Pennsylvania
**Department of
Environmental Protection**

TO Air Quality Permit File PA-04-00740D

RE Comment and Response Document
Shell Chemical Appalachia LLC
Shell Polymers Monaca Site
Potter and Center Townships, Beaver County
APS 1122267; Auth 1500641; PF 775836

Figure 1: BWON Point of Generation

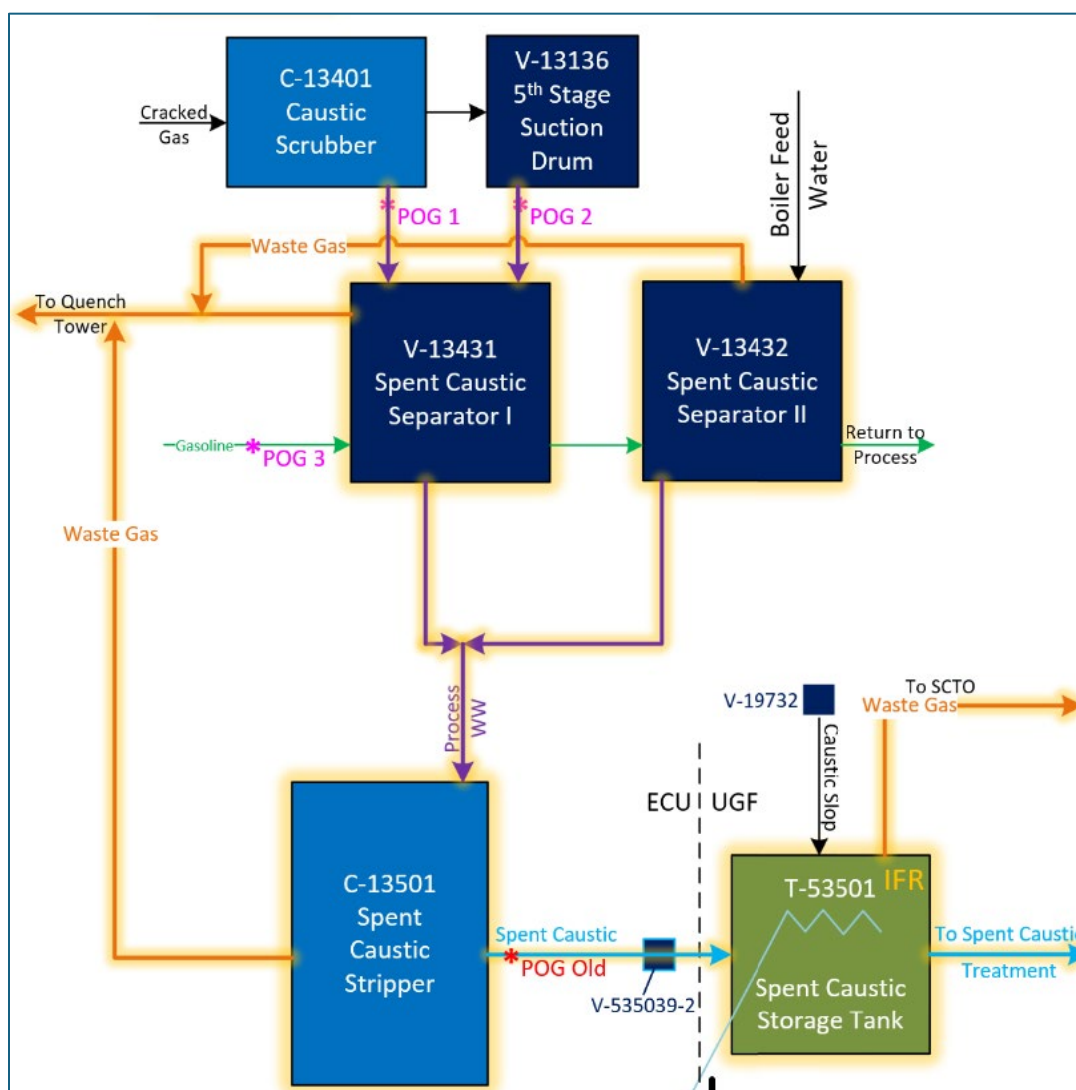
22. **Comment:** Commenters assert that the draft permit improperly authorizes Shell to generate far more benzene waste than existing limits allow. Shell’s existing Plan Approval C requires Shell to comply with the applicable standards of the Subpart FF benzene waste operation NESHAP (“BWON”) “for a facility with benzene waste less than 10 Mg per year (11 tons per year) as specified in 40 CFR §61.342(a), (g), and (h).”²⁹ In addition to complying with BWON, Plan Approval C requires Shell to limit the amount of total benzene quantity from facility waste to less than “11 tons per year as determined through 40 CFR § 61.355.”³⁰

Shell initially represented to DEP that Shell would design and operate the Plant to maintain total annual benzene quantity from facility waste below the 10 Mg/year applicability threshold in Subpart FF (BWON). However, on April 18, 2023, Shell reported to DEP that the amount of total annual benzene quantity generated in the facility’s waste is nearly 60 tons per year, far exceeding the 10 Mg/year TAB threshold under Subpart FF that triggers additional substantive requirements. (850, 854, 855, 858, 861, 864, 865, 867, 868, 869, 878, 881, 882, 884, 931 – 952)

The determination which changed the calculated TABQ from less than 10 Mg/yr to greater than 10 Mg/yr was that the spent caustic stripper within the ethane cracking unit (ECU) was determined to not meet the definition of a ‘sour water stripper’ because it does not remove sulfur or ammonia compounds. Sulfur and ammonia compounds are not present in the spent caustic stream at SPM, and the stream therefore does not require a sour water stripper. This moved the POG from downstream of the stripper to locations upstream of the stripper. See 40 CFR 61.355(b) for TABQ calculation specifics and §61.355(b)(1) for where to determine TABQ from sour water strippers.

Shell has provided the block flow diagram shown in Figure 1 below for a visual representation of this change. “POG Old” was the original incorrectly interpreted location. POG 1, 2, and 3 are the corrected locations for the BWON applicability TABQ determination (other POGs not around the spent caustic stripper are not shown in the below diagram for simplicity).

There was no physical design or as-built change to the process, only a change to the equipment determination. By designating POG upstream of the spent caustic stripper, the spent caustic stripper functionally becomes equipment following best practice standards to reduce benzene from ECU waste. ECU is designed to remove benzene from the cracked gas stream and recover it as reasonably possible as part of the light gasoline or C3+ co-products. The spent caustic stripper removes volatile hydrocarbons including benzene from the spent caustic stream prior to spent caustic leaving the unit boundary and being routed to the spent caustic oxidization area. There is less benzene in the spent caustic stream downstream of the spent caustic stripper than upstream. Benzene and other hydrocarbons removed by the spent caustic stripper are recycled back to the quench tower which is an earlier point of the process within ECU. This constitutes recovery of most of the benzene from the upstream POGs. This recovered benzene does not result in air emissions or enter the WWTP. This recovered benzene is ultimately incorporated into light gasoline or C3+ co-products.
